Work Order ID 125198

Item Name: Upper Guide

APICAL INDUSTRIES, INC.	ENGINEERING CHANGE NOTICE NO. 03724				SHEET 1 OF 1	
	DWG NO. 646.3300	REV: N/C	PREPARED BY B. PETERS	DATE: 12/05/12	EFFECT ON DWG <input type="checkbox"/> INC. <input checked="" type="checkbox"/> UNINC.	
	DWG TITLE: UPPER CUTTER ASSY					
APPROVED BY: ENGR <i>[Signature]</i>		MFG <i>[Signature]</i>		QC <i>[Signature]</i>	EFF: NEXT ORDER	
TRANSACTION CODES (TC): A-ADD C-CREATE R-REVISE D-DELETE		REASON: REVISED ORDINATE DIMENSION.				ECR: D-12-025

APICAL INDUSTRIES, INC.	ENGINEERING CHANGE NOTICE NO. 02196		SHEET 1 OF 2	
	DWG NO. 646.3300	REV: N/C	PREPARED BY S. HUFF	DATE: 01/05/09
	DWG TITLE: UPPER CUTTER ASSY			
	APPROVED BY: ENGR <i>[Signature]</i>	MFG <i>[Signature]</i>	QC <i>[Signature]</i>	EFF: NEXT ORDER
TRANSACTION CODES (TC): A-ADD C-CREATE R-REVISE D-DELETE	REASON: REMOVED RIVETS IN FAVOR OF ADDITIONAL SCREWS

SHEET 1, VIEW 646.3301, IS:

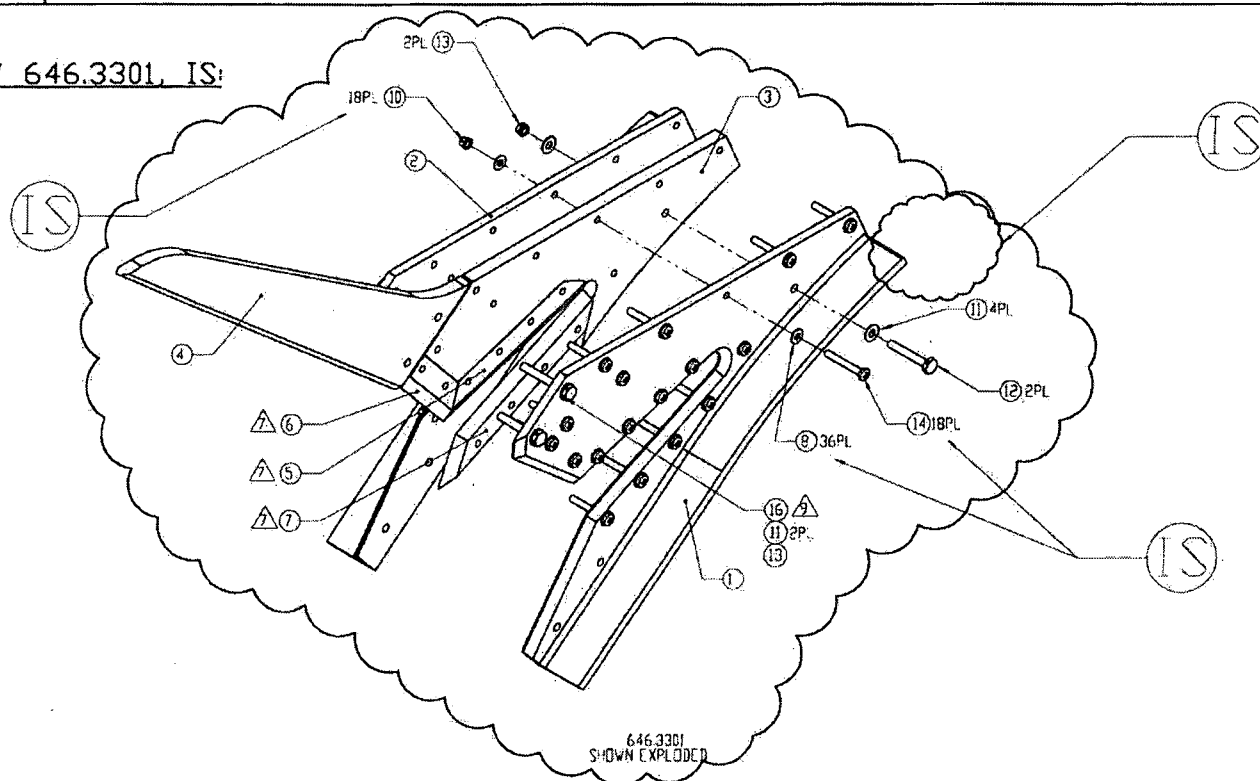
14	R	601.2765	18	SCREW	MS27039-0819
10	R	601.1541	18	LOCKNUT	MS21042L08
9	D	601.2766	3	RIVET	MS20470AD5-18
8	R	601.2764	36	WASHER	NAS1149FN832P
			3301		
F/N	TC	PART NUMBER	QTY	DESCRIPTION	MATERIAL/SPECIFICATION
DOCUMENTS EFFECTED:				<input type="checkbox"/> MDL <input checked="" type="checkbox"/> INSTALL INSTRUC <input checked="" type="checkbox"/> ICA <input type="checkbox"/> FMS <input checked="" type="checkbox"/> BOM	CHANGE CATEGORY <input type="checkbox"/> MAJOR <input checked="" type="checkbox"/> MINOR
				DER REVIEW REQUIRED <input type="checkbox"/> YES <input checked="" type="checkbox"/> NO
